# Access Compliance Report

## Public Rights-of-Way

Intersection ID: 12991	Main Street: E_MOREHEAD_ST	Cross Street: S_TRYON_ST	Location: N
ADA ID: A3A5713BC0D6	Ramp Type: PerpDiag	Initial Pass/Fail: Fail	Overall Compliance: No
			Severity Score: 21.25

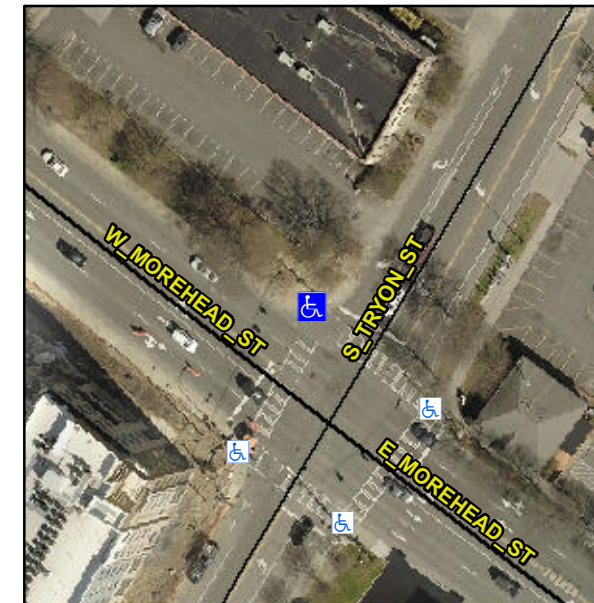
**Not Found, R304.5.1, R304.2.2**

Compliance	Description	Data	Compliance	Description	Data
N/A	Ramp Length (in)	60.0	No	Ramp Slope (%)	10.8
No	Ramp Width (in)	45.0	Yes	Ramp XSlope (%)	0.8
N/A	Flare Type LT	N/A	N/A	Flare Type RT	N/A
N/A	Flare Slope LT (%)	N/A	N/A	Flare Slope RT (%)	N/A
N/A	Flare Traversable LT?	N/A	N/A	Flare Traversable RT?	N/A
N/A	Landing Length (in)	N/A	N/A	DWS Provided?	N/A
N/A	Landing Width (in)	N/A	N/A	DWS Contrast?	N/A
N/A	Landing Slope (%)	N/A	N/A	DWS Length (in)	N/A
N/A	Landing X Slope (%)	N/A	N/A	DWS Full Width?	N/A
N/A	Landing Curb? (Y/N)	N/A	N/A	DWS Offset (in)	N/A
N/A	Shared Landing?	N/A			
N/A	Gutter Ponding?	N/A	N/A	Gutter Slope (%)	N/A
N/A	Gutter Lip Ht (in)	N/A	N/A	Gutter X Slope (%)	N/A
N/A	Painted X Walk1?	Yes	N/A	Painted X Walk2?	Yes
	X Walk 1 Direction	To SW		X Walk 2 Direction	To SE
N/A	X Walk 1 Width (in)	112.0	N/A	X Walk 2 Width (in)	111.0
	X Walk 1 Slope (%)	4.9		X Walk 2 Slope (%)	2.7
	X Walk 1 X Slope (%)	2.0		X Walk 2 X Slope (%)	3.5

**Remove & Replace Curb Ramp With Two New Directional Ramps or Equivalent.**
